## **Arlington Conservation Commission**

Date: Thursday, March 7, 2024

#### DEP #091-0356: Notice of Intent: Thorndike Place (Continuation from 2/15/2024).

# <u>DEP #091-0278: Amendment to Order of Conditions: 88 Coolidge Road (Continued from 2/15/2024).</u>

FILE: 2340702\C\D\2340702-LN SHEET G-101JOB. NO: 23407.02

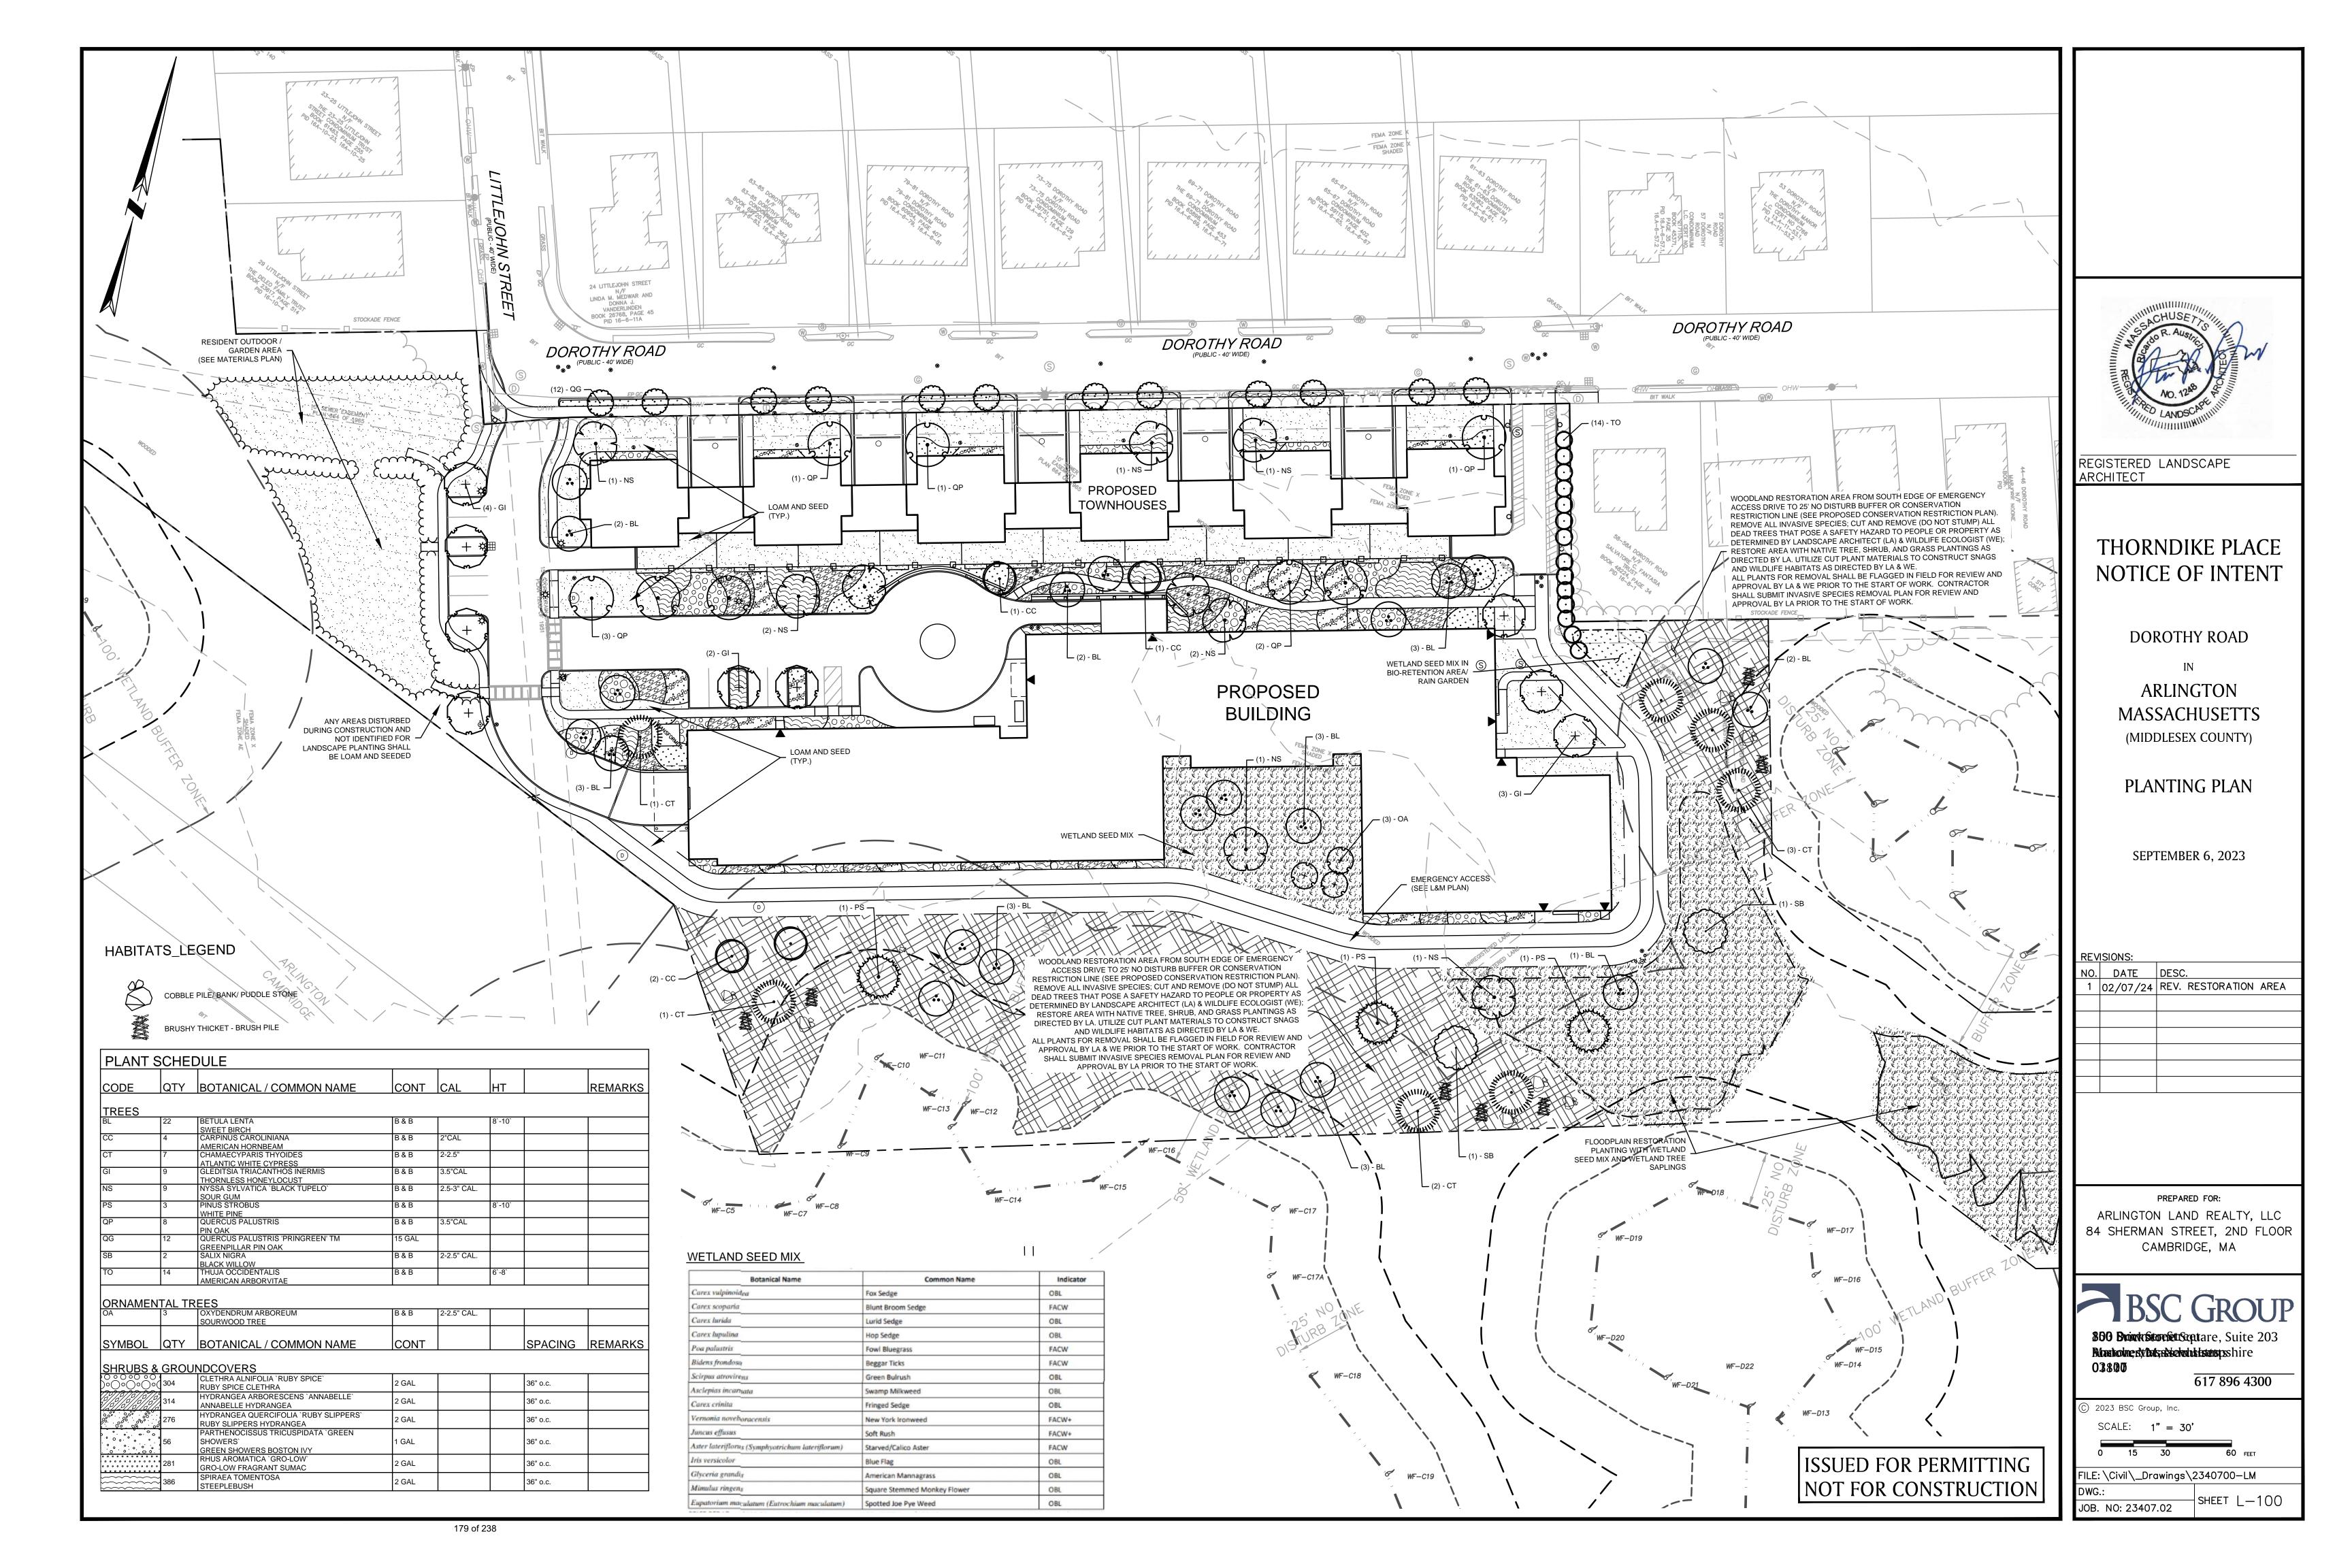
SWCA Comment 6: Sheet G-101, Planting Notes, Note 11. The site plans indicate that the plant species indicated on the plant list are recommendations only and that final selection of the species shall occur at the time of plant purchase, depending on availability and that the size and quantity shall not change without approval of the Applicant's landscape architect.

<u>SWCA Comment 7:</u> Sheet G-101, Comprehensive Permit Notes, Comment I.5. This comment notes that dumping of woody vegetation, brush, and other debris in a resource area or its associated buffer zone is prohibited.

<u>SWCA Comment 8:</u> Sheet G-101, Comprehensive Permit Notes, Comment I.25. The site plans note that the survival rate of planted species shall be 80% at the end of the third year and that a corrective action plan must be submitted if the survival rate is less than 80% at the end of the third year.

<u>BSC Response 6:</u> BSC has made the recommended revision to the Sheet G-101 Planting Notes, Note 11. We recommend that the Order of Conditions allow administrative approval of such availability-based changes by the Conservation Commission or its authorized representative to prevent undue construction delays in making such substitutions if necessary.

BSC Response 7: Sheet G-101, Comprehensive Permit Notes, Comment 1.5 is a Condition of the Comprehensive Permit, and the wording is copied directly from that Condition. The intent of the Condition is to prohibit the dumping of materials removed during construction in the wetlands or buffer zone. In accordance with BSC Response 4 above, the Restoration Plan will be updated with detailed natural coarse woody debris and stone wildlife habitat features using materials originating from the site, but material removed from the site during construction will not be disposed of within resource areas or associated buffer zones in accordance with the Comprehensive Permit condition.

<u>BSC Response 8:</u> Sheet G-101, Comprehensive Permit Notes, Comment I.25 is a condition of the Comprehensive Permit, and the wording is copied directly from that Condition. The Comprehensive Permit Condition was prepared upon the recommended conditions submitted to the Zoning Board by the Conservation Commission by letter dated October 14, 2021.
